PLANNING COMMISSION MEETING

RE: Culver's- Preliminary Site Plan Review – 2nd Review

RE: Culver's
Preliminary Site Plan – Review #2

C100

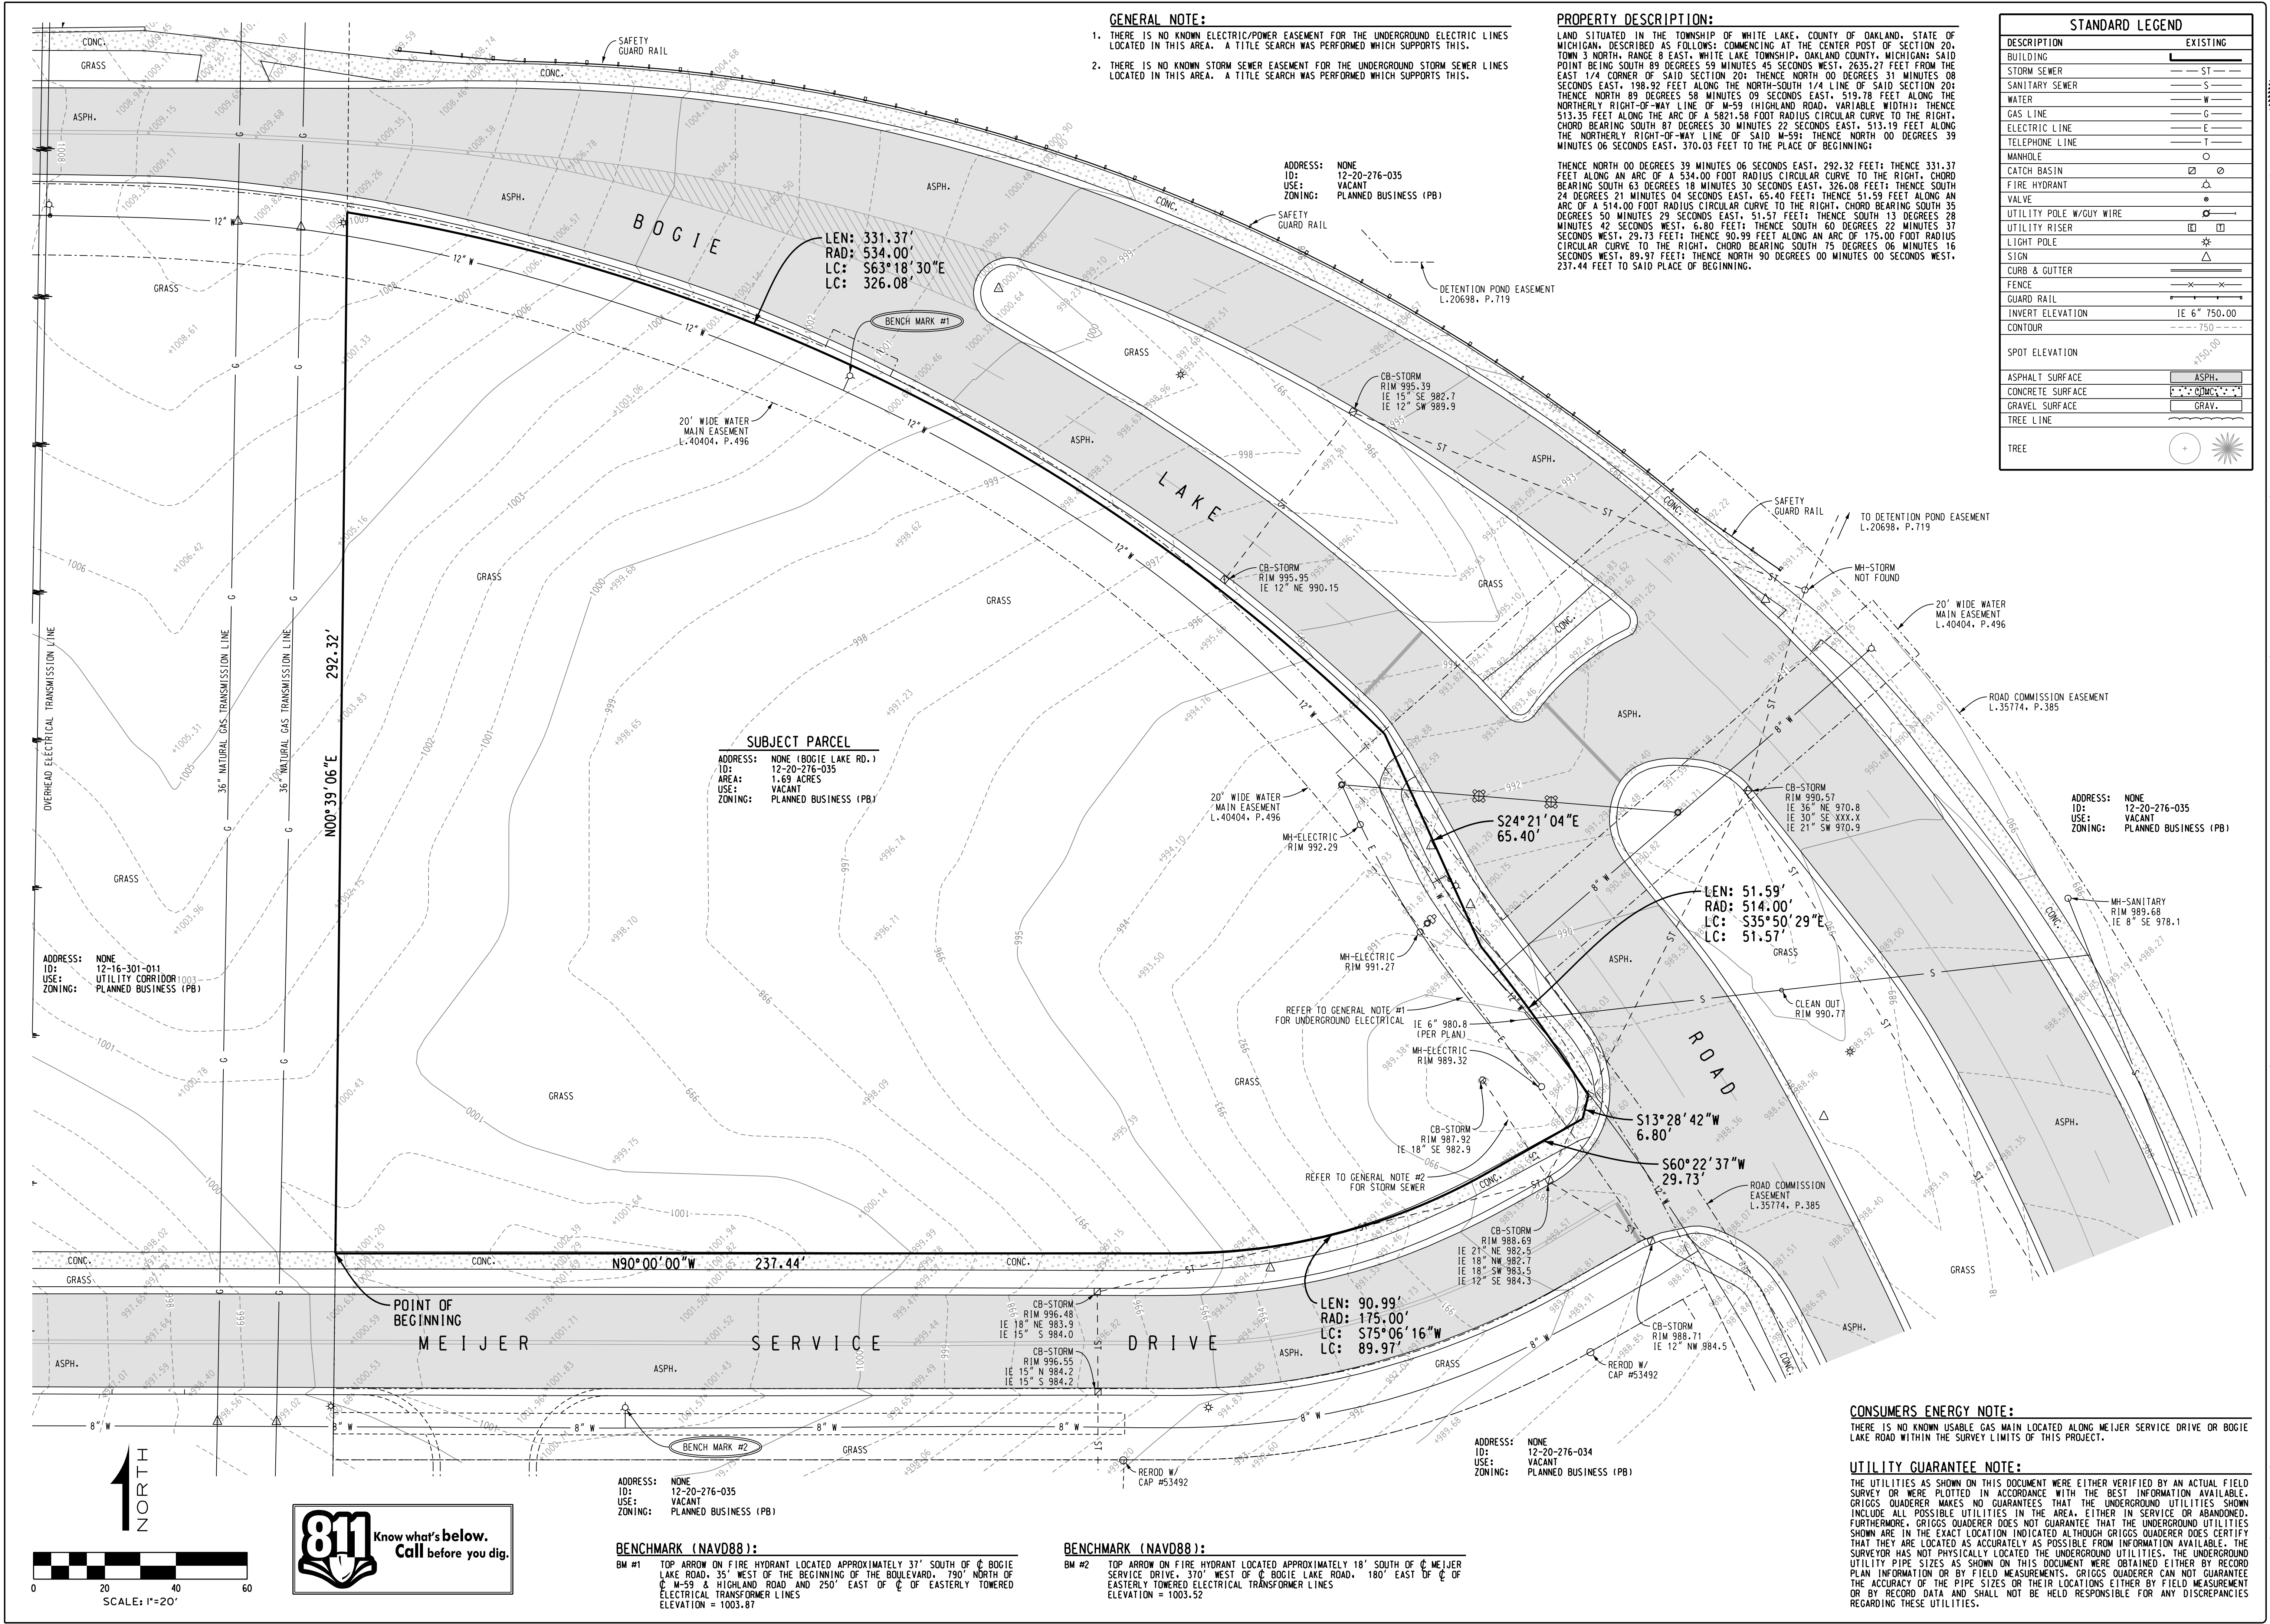
- b) *Sheet C100- Show existing watermain easement for watermain along Bogie Lake Road frontage. In addition, any work within the existing easement shall require permission from the Township. **Comment addressed and remains as a notation regarding permission for work within the existing easement. The 20' wide recorded watermain easement along Bogie Lake Road has now been shown.***

- c) *Sheet C100- Indicate whether there is an existing easement for the existing on site electric/power line. If so, permission from DTE shall be required for work within this easement. **Comment addressed. Per the design engineer, no DTE easement was found during the title search.***

- d) *Sheet C100- Indicate whether there is an existing easement for the existing on site storm sewer (EX1 to EX2). **Comment addressed. Per the design engineer, no easement for storm sewer was found during title search. This portion of the existing storm sewer shall require an easement since it is outside of the existing ROW.***

- e) *Sheet C100- Storm MH EX1- Verify rim and invert elevations. Per attached Meijer storm sewer as built plan, rim and invert as built elevations shown on the Culver's survey differ by approximately 2-3 feet. **Comment addressed; grades were confirmed by surveyor.***

- f) *Sheet C100- Storm MH EX2- The following pipe sizes appear in error based on attached Meijer storm sewer as built plan a) 24" should be 21" diameter b) 15" should be 18" diameter. **Comment addressed. Pipe sizes have been revised.***

- g) *Sheet C100- It appears that the existing storm sewer in Bogie Lake Road to the east is also mislabeled in terms of pipe diameter. Meijer as built plan shows 21" and 36" diameters respectively. Please verify. **Comment addressed. Pipe sizes have been revised.***

- h) *Sheet C100-Benchmark #2 elevation (1003.52) shown appears to deviate by approximately 1.05' versus the identical benchmark (1004.57') provided on the survey(attached) for the adjacent (proposed Panera Bread) property to the southwest. Please clarify. **Comment addressed; grades were confirmed by surveyor.***

- i) *Sheet C100- The following three distances in the Property Description are missing from the property metes and bounds sketch: a) Second paragraph- Line 1-331.37'; b) Second paragraph-Line 4-51.59'; c) Second paragraph-Line 8-90.99'. **Comment addressed. Lengths of curves have now been added to the property metes and bounds sketch.***

C200

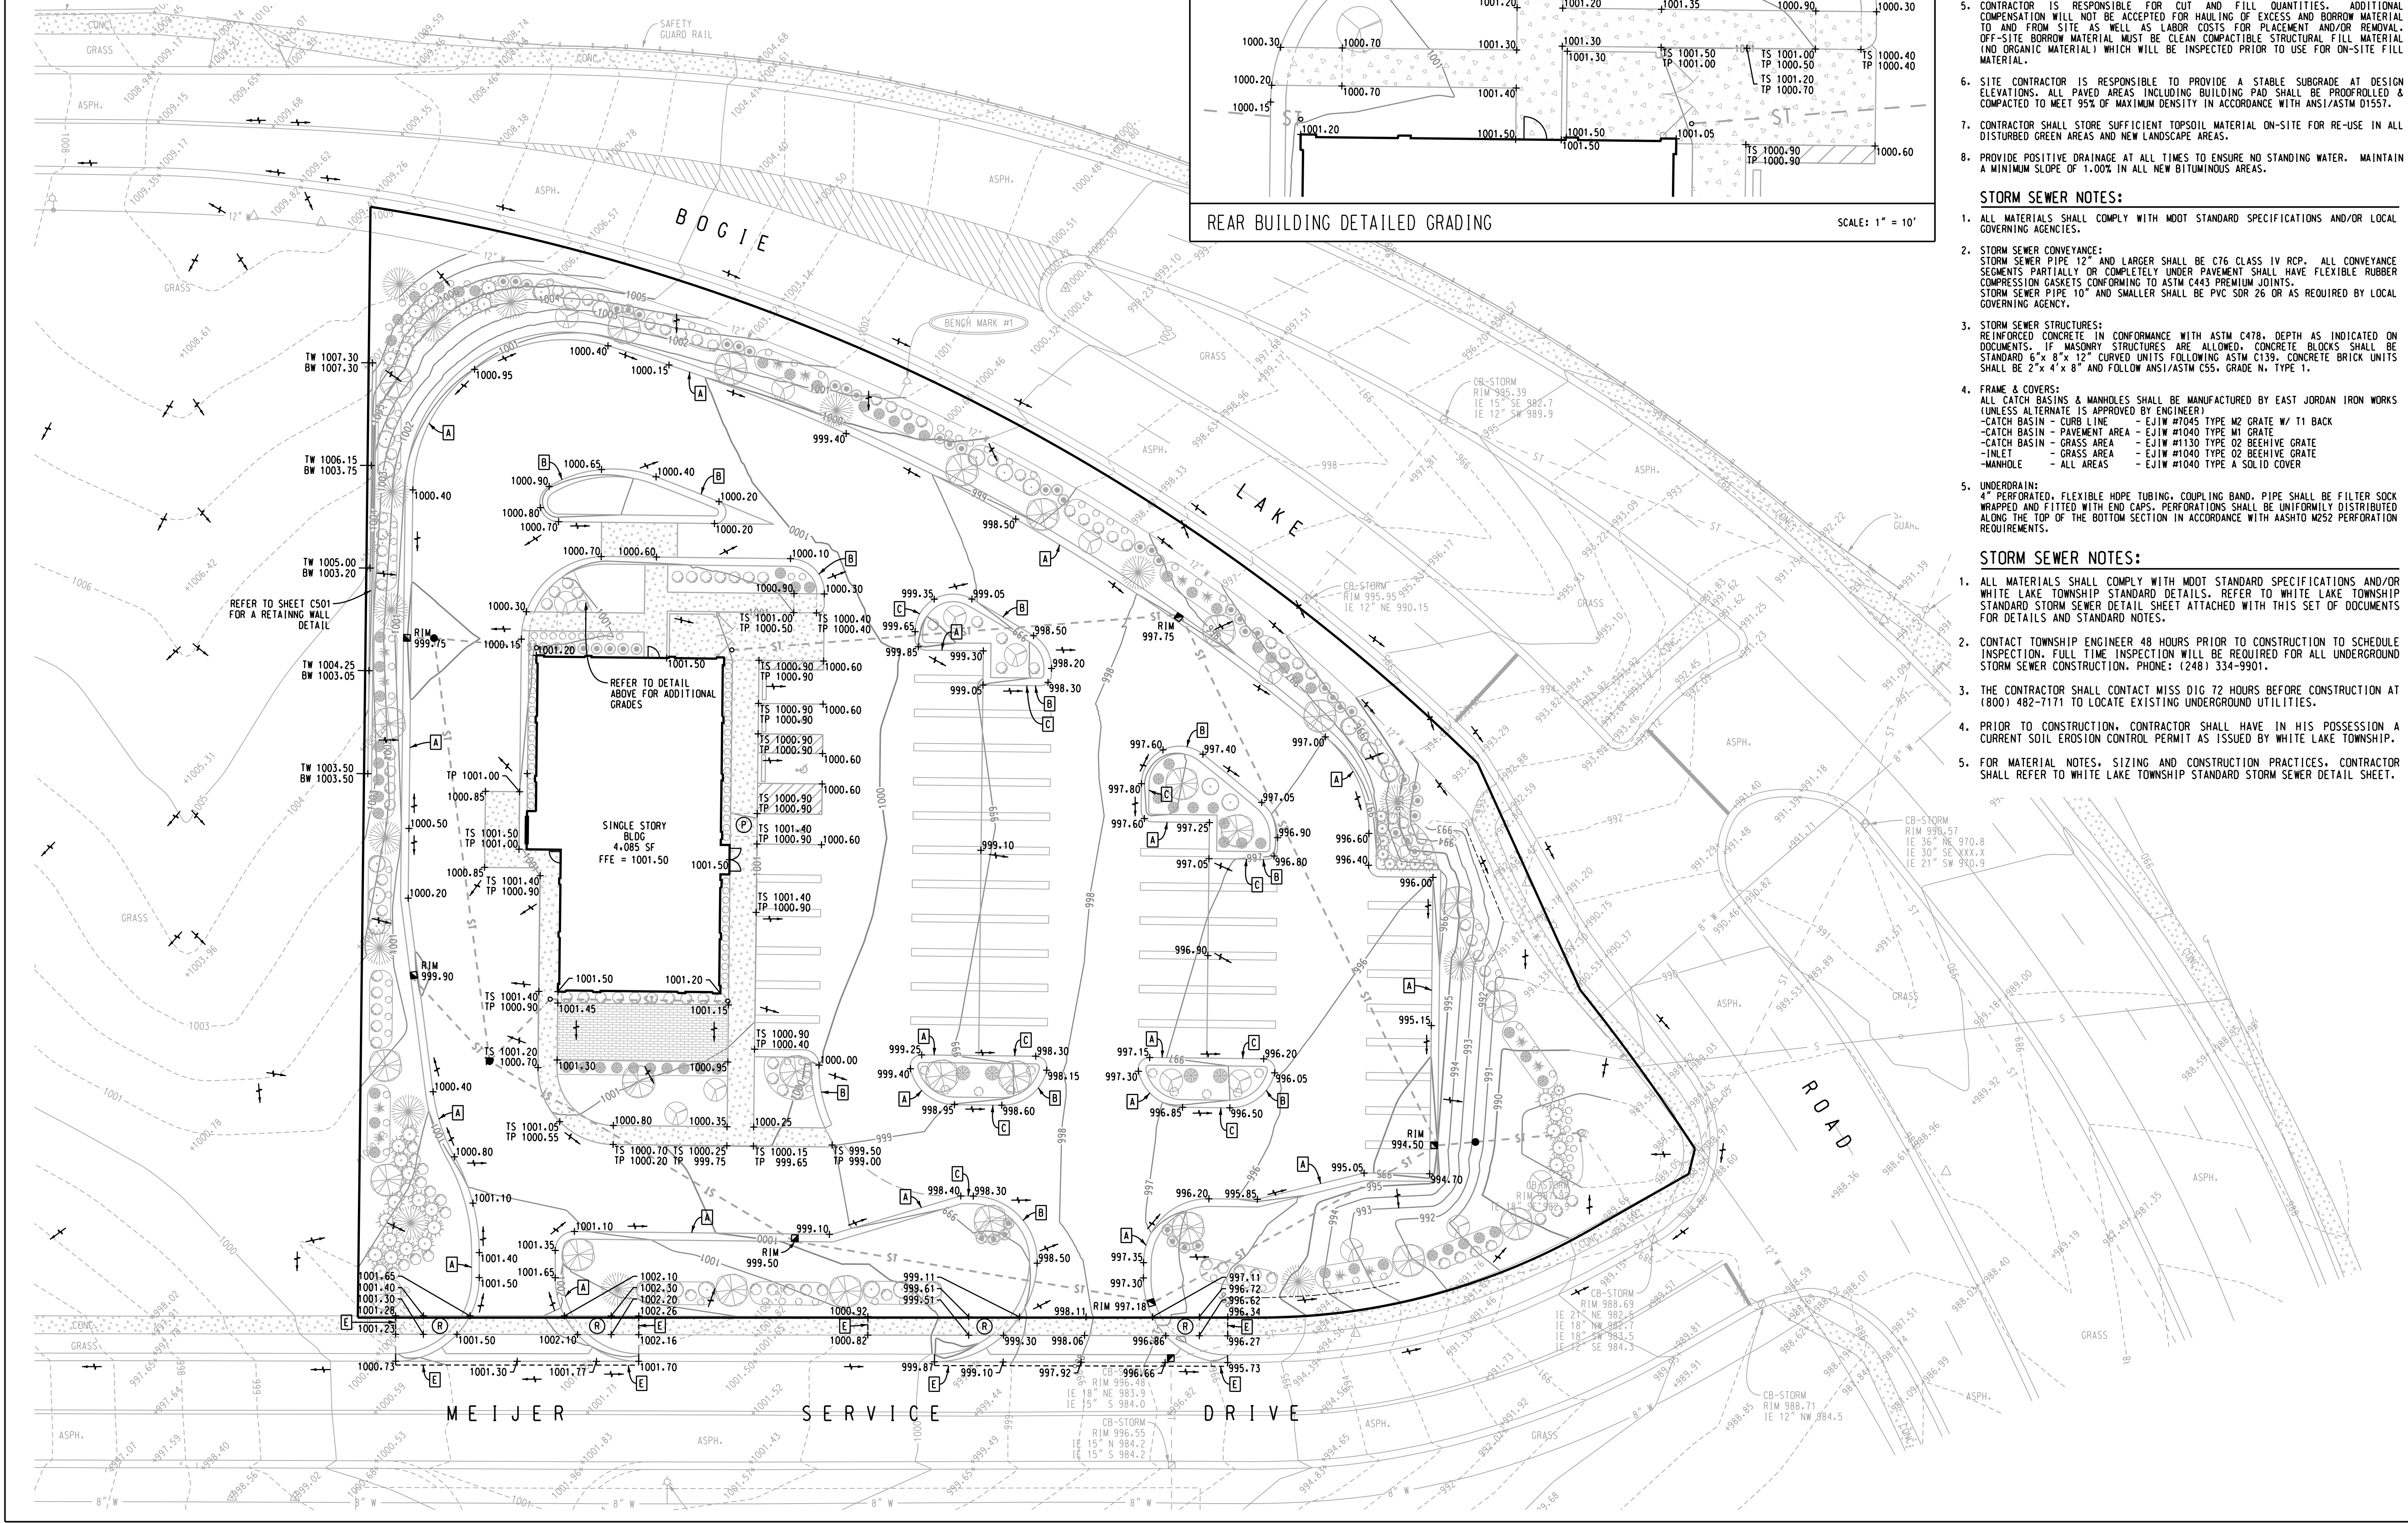
- j) *Sheet C200- It is not clear why bumper blocks are being proposed where the ADA parking + one regular parking space abut the proposed sidewalk. Although the sidewalk abutting the spaces with bumper blocks will not be raised, the sidewalk to the south at a point would still need a sloped sidewalk/ramp up to allow ADA customers access to the restaurant door since the southern portion of this sidewalk does indicate a 6" raised sidewalk. Please review. **Comment addressed and remains as a notation. The design engineer notes the sidewalk adjacent to the bumper blocks shall be flush with the pavement area, with a ramp up to the main entrance proposed. Details for ramp up to main entrance along with proposed grades (meeting ADA requirements) shall be provided on the FSP/FEP.***

- k) *Sheet C200-The 15' wide one way driveway on the south side of the restaurant does not meet the Township minimum 20' width requirement for one way drives. We defer to the Township Planning*

Department regarding this item. Comment addressed and remains as a notation. Per the design engineer, Culver's shall be requesting a variance for the reduced drive width. We continue to defer to the Township regarding this item.

- l) *Sheet C200- Clarify the sidewalk easement intent for the existing sidewalks along the Meijer Service Drive and Bogie Lake Road. Is the easement proposed or existing? In addition, we defer to the Township Planning Department as to whether the existing sidewalk along Bogie Lake Road shall be required to be extended to the northwest along the Bogie Lake Road frontage per Township Zoning Ordinance requirements. Comment addressed and remains as a notation. A portion of the existing sidewalk is within the Culver's property and the design engineer has stated the intent to grant pedestrian access along the existing sidewalk to allow for continued use. We continue to note the requirement for a sidewalk easement for the portion of sidewalk on the Culver's property that is outside the Bogie Lake Road ROW. We continue to defer to the Township as to whether the existing sidewalk along Bogie Lake Road shall be required to be extended to the northwest along the Bogie Lake Road frontage.*

Two proposed driveways to the Meijer private drive would provide access to the site. The Zoning Ordinance states the number of driveways permitted for a site shall be the minimum number necessary to provide safe and efficient access for regular traffic and emergency vehicles. **The westerly driveway should be eliminated. Revise accordingly.** (Comment remains as a notation. The Applicant is requesting a secondary driveway be allowed on the west side of the site. Staff defers to the Planning Commission on this request. It should be noted the Applicant is also requesting a waiver to reduce the required drive aisle width for a one-way drive along the south side of the building from 20 feet to 15 feet). **If not removed, the westerly driveway is deficient in width (one-way undivided driveways must have a width of 20 feet) and shall be widened accordingly (dimension this driveway width on Sheet C200).** (Comment addressed. The drive width has been labeled with dimensions on Sheet C200).

An outdoor patio with 20 seats (five tables) is proposed on the south side of the building. **Label the size (square footage) of the patio on Sheet C200.** (Comment addressed. A note has been added to Sheet C200 indicating the patio is 675 square feet in size).
